Access Compliance Report

Public Rights-of-Way

Intersection ID: 5749	Main Street: NEVIN_RD	Cross Street: WHITE_PINE_LN	Location: SE
ADA ID: 516B998FECBB	Ramp Type: Perp	Initial Pass/Fail: Fail	Overall Compliance: No
		Severity Score: 10

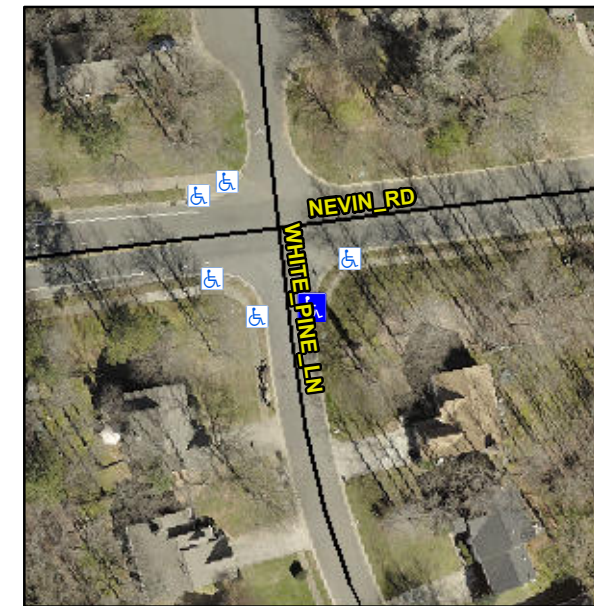
Not Found, R304.5.1, R304.5.3

Compliance	Description	Data	Compliance	Description	Data
N/A	Ramp Length (in)	46.0	Yes	Ramp Slope (%)	6.6
No	Ramp Width (in)	47.0	No	Ramp XSlope (%)	2.8
N/A	Flare Type LT	N/A	N/A	Flare Type RT	N/A
N/A	Flare Slope LT (%)	N/A	N/A	Flare Slope RT (%)	N/A
N/A	Flare Traversable LT?	N/A	N/A	Flare Traversable RT?	N/A
N/A	Landing Length (in)	N/A	N/A	DWS Provided?	N/A
N/A	Landing Width (in)	N/A	N/A	DWS Contrast?	N/A
N/A	Landing Slope (%)	N/A	N/A	DWS Length (in)	N/A
N/A	Landing X Slope (%)	N/A	N/A	DWS Full Width?	N/A
N/A	Landing Curb? (Y/N)	N/A	N/A	DWS Offset (in)	N/A
N/A	Shared Landing?	N/A			
N/A	Gutter Ponding?	N/A	N/A	Gutter Slope (%)	N/A
N/A	Gutter Lip Ht (in)	N/A	N/A	Gutter X Slope (%)	N/A
N/A	Painted X Walk1?	No	N/A	Painted X Walk2?	N/A
	X Walk 1 Direction	To W		X Walk 2 Direction	N/A
N/A	X Walk 1 Width (in)	N/A	N/A	X Walk 2 Width (in)	N/A
	X Walk 1 Slope (%)	5.1		X Walk 2 Slope (%)	N/A
	X Walk 1 X Slope (%)	3.1		X Walk 2 X Slope (%)	N/A

Remove & Replace Entire Ramp.
